V2500-A1/A5/D5 SERIES PROPULSION SYSTEM SERVICE BULLETIN

This document transmits the Revision 1 of Service Bulletin V2500-ENG-72-0592.

ENGINE – TUBE, NO.4 BEARING ASSEMBLY PRESSURE – MODIFICATION TO PREVENT CRACKING OF
WELD REPAIRED PARTS

LOCATION OF THE NO.4 BEARING ASSEMBLY PRESSURE TUBE
72-42-20
FIGURE 1

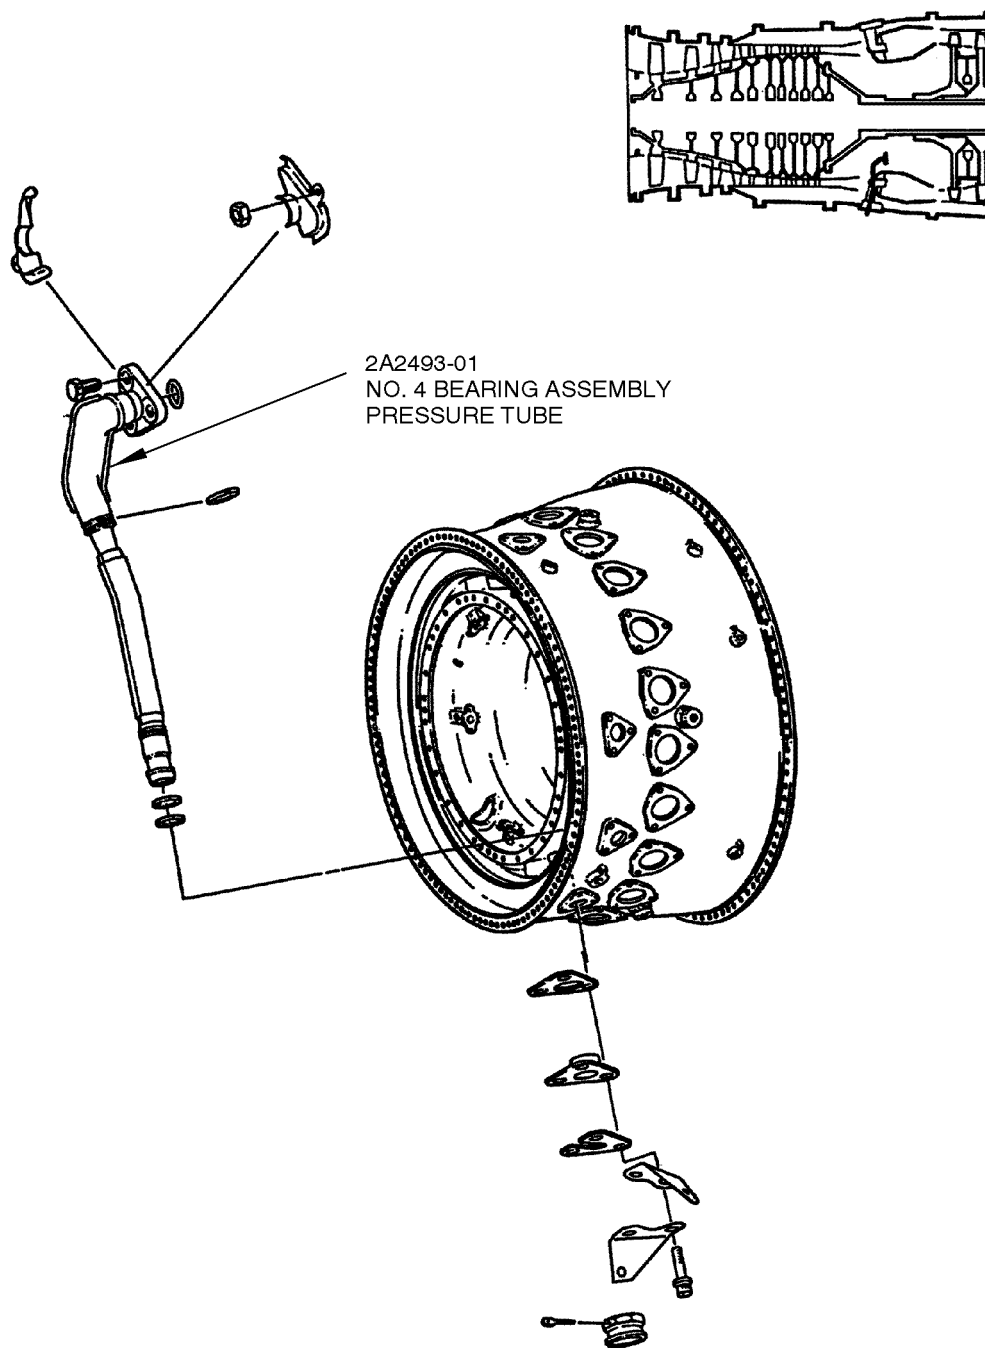
(a) A V2500 engine experienced oil loss outside of the No.4 bearing compartment due to a crack in the No.4 oil pressure tube, resulting in oil ignition outside of the No.4 bearing compartment.

(a) Investigation determined the crack is attributed to the weld repair per VRS3642 of the upper seal land area performed during a previous shop visit. The subject repair, VRS3642, has been removed from the Engine Manual by a temporary revision. An existing alternate repair for the No.4 bearing pressure tube seal land area will still be available, VRS3728, which will replace the tube section. All tubes will either be repaired, if required, to VRS3728 or replaced new.

(a) Introduce a new No.4 bearing assembly pressure tube part number to distinguish tubes in-service that have been repaired to alternate existing repair VRS3728 or that have never had repair VRS3642 accomplished. Tubes that have not been repaired per VRS3642 need to be reidentified to the new part number at next exposure. Tubes that have been repaired per VRS3642 need to be either repaired per VRS3728, then re-identified to the new part number, or scrapped.

- (1) If you have a No.4 Bearing Assembly Pressure Tube, P/N 2A2493-01 that was previously repaired by Reference 3 or 4, Component Maintenance Manual, VRS3642 or if you have a No.4 Bearing Assembly Pressure Tube, P/N 2A2493-01 and it cannot be determined whether it has been repaired by Reference 3 or 4, Component Maintenance Manual, VRS3642, then do one of the procedures that follow. See Figure 1 for the location of the part.

- (a) Replace No.4 Bearing Assembly Pressure Tube, P/N 2A2493-01 with P/N 2A4256-01. Refer to the list that follows for old and new part numbers.

- (b) Send No.4 Bearing Assembly Pressure Tube, P/N 2A2493-01 to the following approved source:

NOTE: The approved source will remove and replace two tube details, reidentify the No.4 bearing assembly pressure tube as P/N 2A4256-01 and return the No.4 bearing assembly pressure tube to you.

- (d) Install the modified No.4 Bearing Assembly Pressure Tube, P/N 2A4256-01 per standard overhaul procedures. Refer to the list that follows for old and new part numbers.

- R (2) If you have a serviceable No.4 Bearing Assembly Pressure Tube, P/N 2A2493-01 that was never repaired by Reference 3 or 4, Component Maintenance Manual, VRS3642, then do the procedure that follows:
- (a) Reidentify the No.4 bearing assembly pressure tube as specified in Reference 5 or 6, Standard Practices Manual, Task 70-09-00-400-501, Procedures to Make Permanent Identification and Location Marks. Approved marking methods are deep electrolytic etch, metal stamp (press or roll), vibration peen (manual or mechanical), engraving (manual or mechanical), or drag impression. Refer to the list that follows for old and new part numbers.
